SERVICE BULLETIN

No. M 6-III/2

Object: Replacement of the connecting rod of MINOR 6-III engine of the production Nos from 33650 to 33899.

SERVICE BULLETIN

Some cases of loosening of valve parts of the fuel supply,
drawing No. 3000094

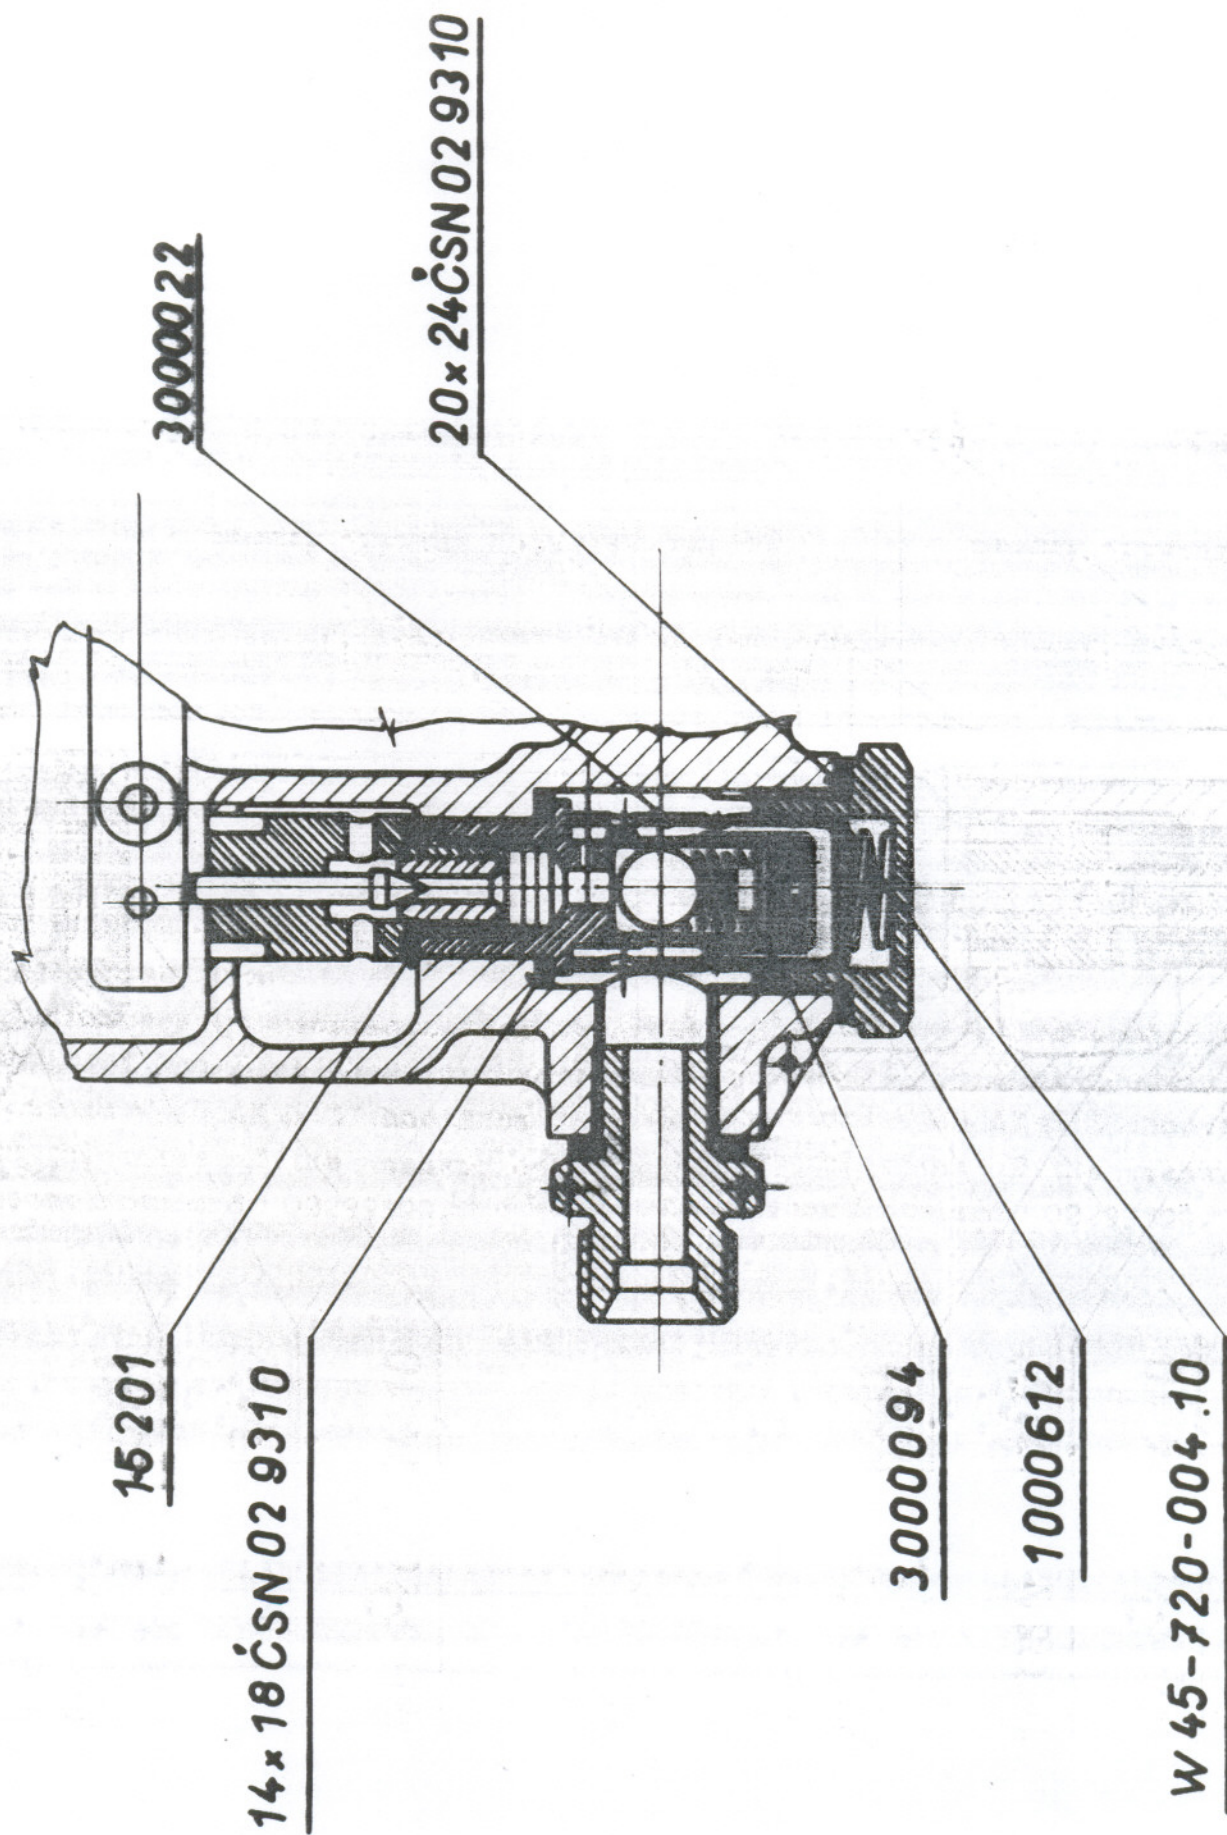
At the next regular inspection of the M 6-III engine or at the incidental control of the adjustment of carburettors, the manufacturing plant recommends that the control of the strength of the thread interconnection at the top and bottom part of the fuel supply valve be carried out.

- 1) Release and screw off the fuel supply plug,
drawing No. 10000612
- 2) Remove the cleaner spring, drawing No. W 45-720-004.10
with sealing washer, drawing No. 20 x 24,
Czechoslovak Standard 02 9310

- 3) Remove the sieve, drawing No. 3000022
- 4) Unscrew the fuel supply valve, drawing No. 3000094 with
sealing washer 14 x 18, Czechoslovak Standard 02 9310

- 5) Fix at the hexagon head, i.e. into the nut wrench the dismantled fuel supply valve, put the lateral spanner on the cut-out of the valve 9 top part and perform check tightening. In case that the sealing washer drawing No. 1-5201 between the two valve parts is damaged, it must be replaced by a washer of the same thickness.

- 7) Put in the sieve, drawing No. 3000022
- 8) Put on the sealing washer 20 x 24, Czechoslovak Standard 02 9310
- 9) Put in the spring of the cleaner, drawing No. W 45-720-004.10
- 10) Screw in and secure the fuel supply plug, drawing No. 10000612

epoxide resin will be made use of for the carburettor W 45 AK 6 Z from the prod. No. M-911380 for strengthening the thread interconnection.

In relation to this measure we recommend that eventual additional adjustment of the fuel head in the float chamber of carburettors W 45 AK 6 Z should be done by only adjusting the thickness of the washer, drawing No. 14 x 18, Czechoslovak Standard 02 9310.

Fig. 2 - Wiring diagram of PALAX ignition magnetoes, model LUN 2221.13
1 - L.H. side magneto
2 - R.H. side magneto
3 - Accumulator (battery)
4 - Pushbutton switch
5 - Start-signalling buzzer
6 - Change-over switch of ignition magnetoes.

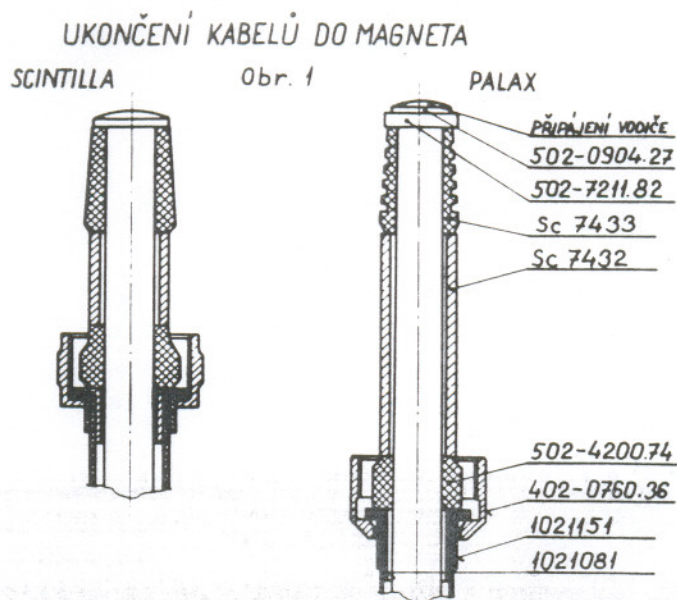
- 1) When replacing a defective Scintilla ignition magneto provided with a break-off coupling, Part No. OBF 6R 701 Z 170 (or the primary design, Part No. OAF 6R 602 Z 170 or AVK 6-Z2) with a PAL ignition magneto, it is necessary to fit additionally a start-signalling buzzer, Part No. LUN 2231, into the ignition circuit of the engine and to replace the starter motor switch pushbutton (see Bulletins Nos. Z 226(126)/25, Z 326/71 and Z 526/42).
- 2) When replacing, however, a defective ignition magneto without any break-off coupling, Part No. OBF 6R 501 Z 170 (or the primary design, Part No. OAF 6R 402 Z 170, or NVK 6-Z2) with a PAL ignition magneto, no start-signalling buzzer is to be fitted in.

NOVÉ PROVEDENÍ
СТАЛО
NEW DESIGN

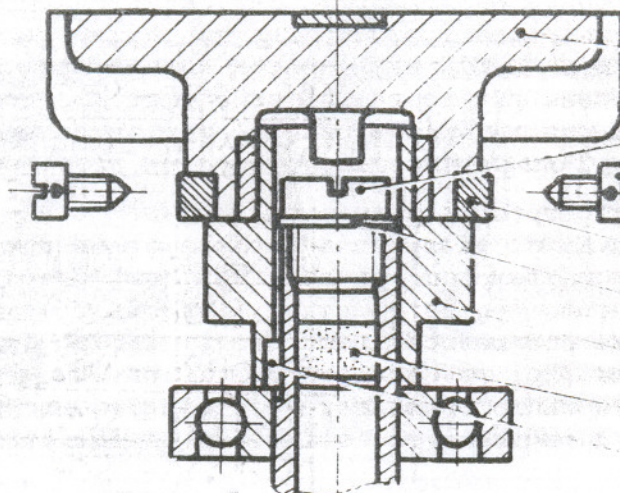
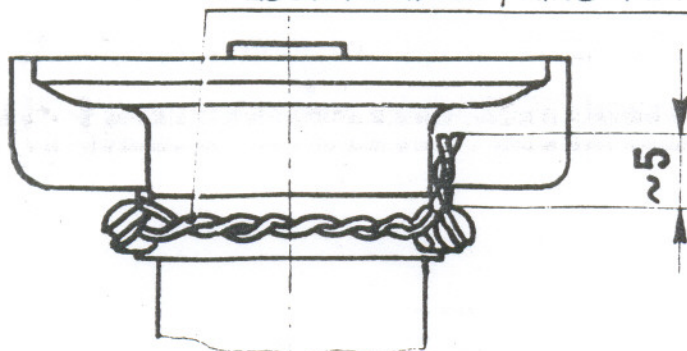
If necessary to replace a distributor rotor arm of the primary (original) design with a distributor rotor arm of the new design, in such a case has to be replaced also the contact breaker cam of the primary (original) design with a cam of the new design, as the primary design in comparison with the new design of the contact breaker cam is rather different.

Fig. 1 - Adaptation of a flanged edge of the cable shoe sleeve,
Part No. 8802.05.

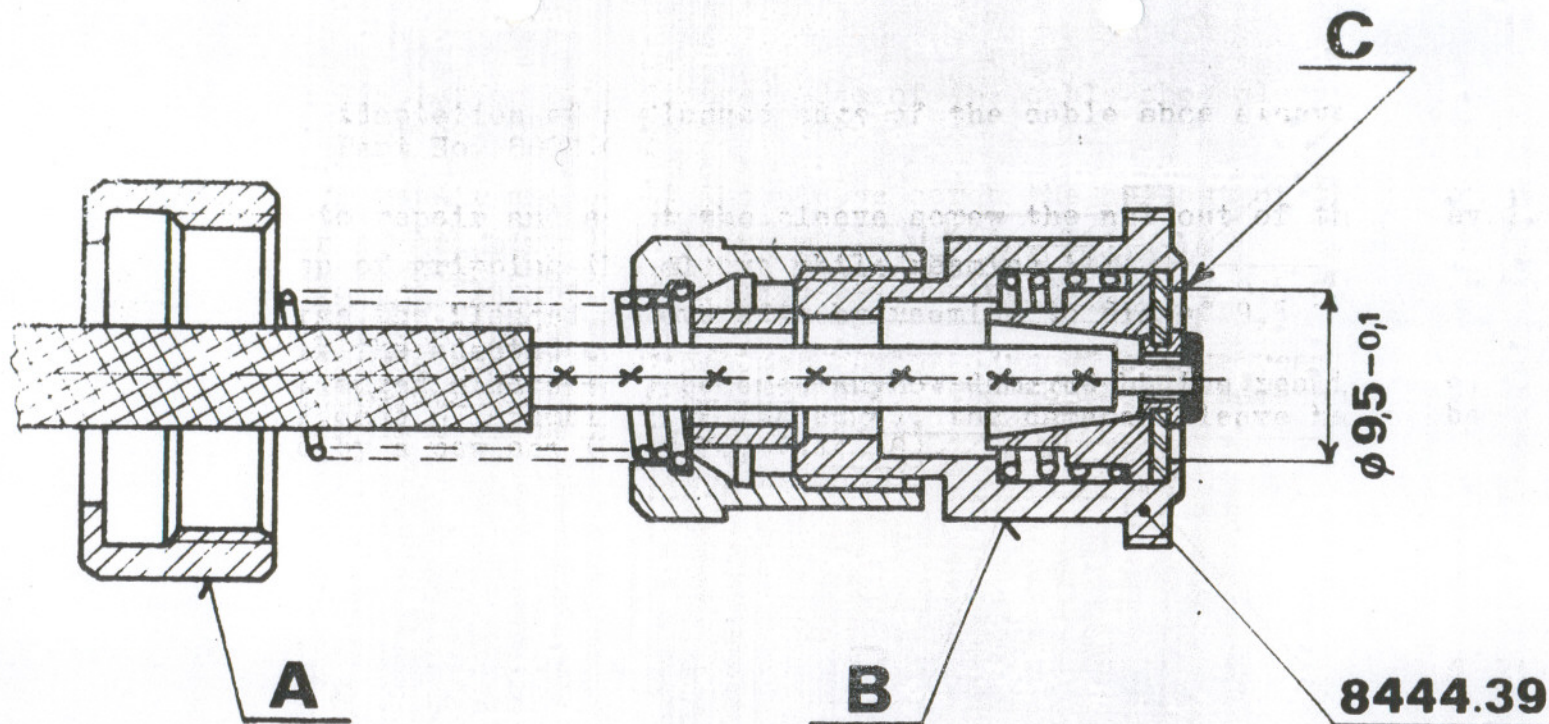
- A - When going to repair and adapt the sleeve screw the nut out of the sleeve;
- B - The location of gripping the sleeve while reaming it;
- C - 1) To enlarge the flanged sleeve edge by reaming to dia of 9,5 -0,1mm;
2) To deburr the adapted edge;
3) If the flanged sleeve edge becomes anyhow damaged by the reaming (e.g. in case of crumbling of the edge), the damaged sleeve has to be replaced by a new one (Part No, 8444.39).
